SUBJECT: PALISADES PLANT-CABLE TRAY SUPPORTS

Subject PALISADES PLANT - CABLE TRAY SUPPORTS

As part of a recent Auxiliary Feedwater Project, Bechtel Corporation was charged with the responsibility of investigating the structural capability of cable tray supports in the southeast corner of the 1C Switchgear Room to carry additional fireproofing loads (Attachment 1). Bechtel's structural analysis concluded that the existing supports were not adequately designed for seismic loads. The analysis also concluded that supports west of the trays to be fireproofed were not adequately designed (Reference 1). The purpose of this letter is to describe the actions that Consumers Power Company has taken to resolve the Bechtel concern, to respond to subsequent NRC questions related to this issue, and to resolve the issue of cable tray support adequacy at Palisades.

115°C SWITCHGEAR ROOM
TRAY & CONDUIT LAYOUT
EL. 600'-0"

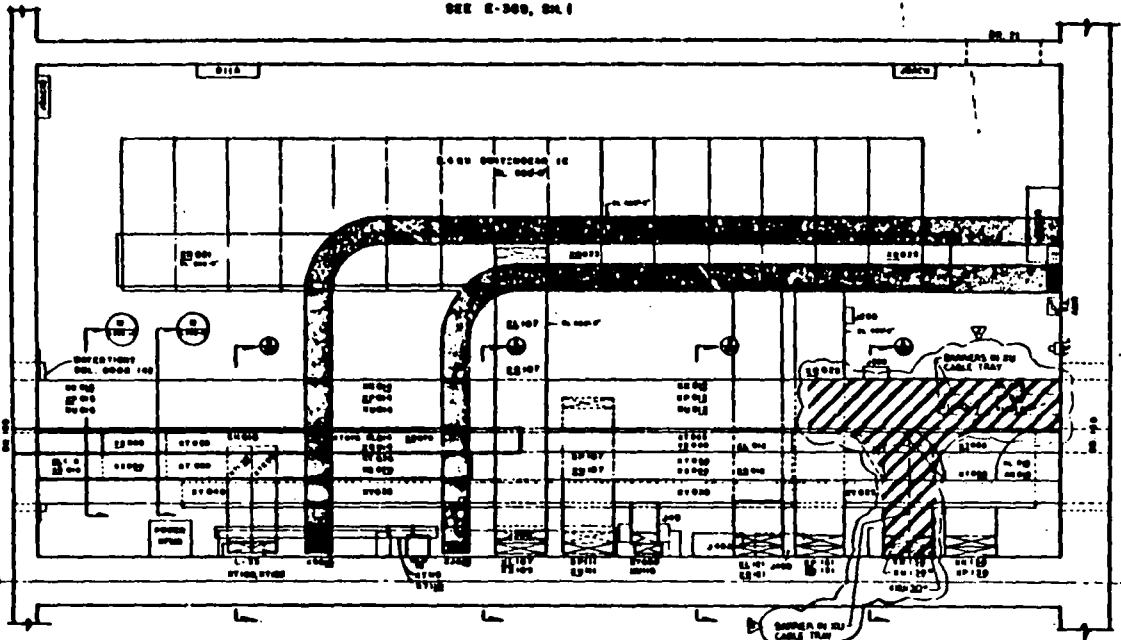
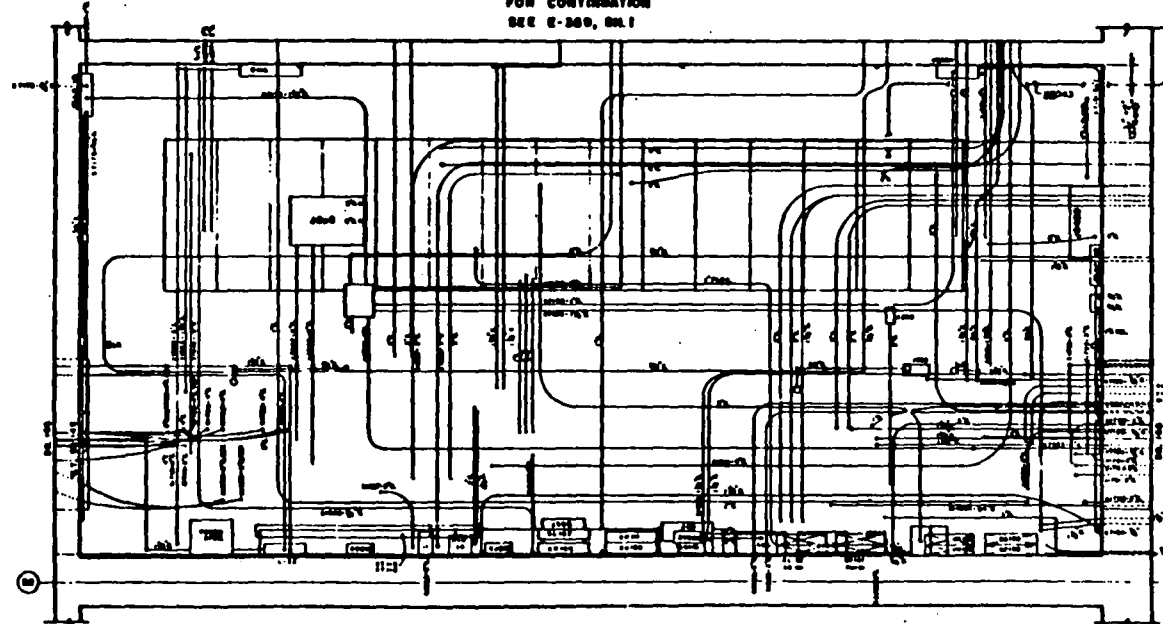
In response to the conclusions reached in Bechtel's analysis, Consumers Power Company authorized Bechtel to strengthen the supports for only those trays designated to be fireproofed. The additional tray support was installed by Bechtel prior to fireproofing the trays; a project which was closed out on June 18, 1984 (Attachment 1).

- DENOTES FIRE PROTECTED CABLE TRAY - FIRE PROTECTION MATERIAL, INSTALLED PER SPECIFICATION & LOCAL PROCEDURE. HEAT AND INSTALLATION TO BE SEPARATE AND NON-TOI.
- DENOTES CABLE TRAY SECTIONS TO BE WITHIN THE PROTECTIVE ENVELOPE.

Project PALISADES - FIRE PROTECTION		Sheet 4 of 12
Job No. 5221	File No. 5221-140	UFI Area 9m
Subject CONDUIT X1885-3" Pull Box Support		UFI System 023FL
Originator Y FENAN	Date 3/15/84	UFI Equipment -
Reviewer OC DOEPP	Date 3/19/84	Calc. Table No. 5221-6B-1

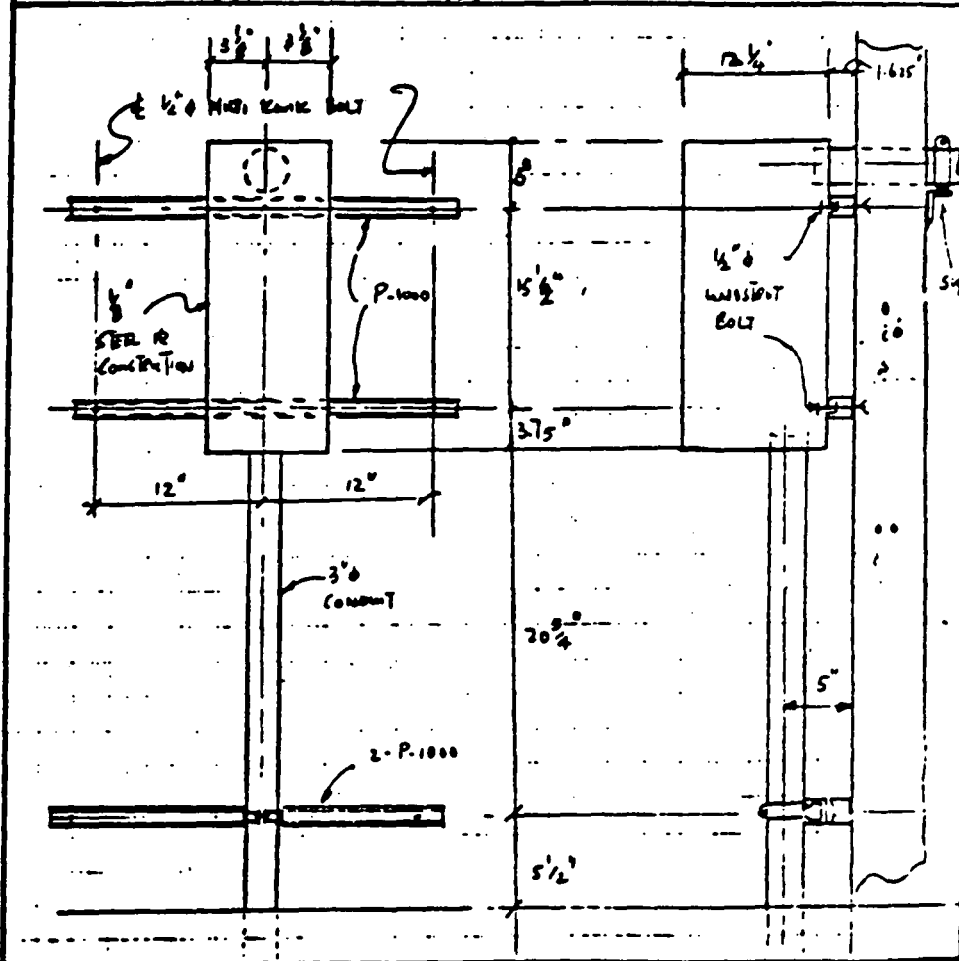
With reference to Specification Change SC-84-043, I have performed structural analysis on the J-box support due to adding 1/2" Thermo-lag at 3.5 lb/ft², and found that the supports are adequate.

The structural analysis I performed was based on the J-box and support configuration as shown on the attached sketch. The dimensions shown on the sketch were provided to me by you, either orally or on sketches dated 3/6/84. In the analysis, I considered only the dead load and seismic load of the box, conduit, and supports. A copy of the calculation (calculation #5221-CR-1) is filed in FM&P file #5221-140.
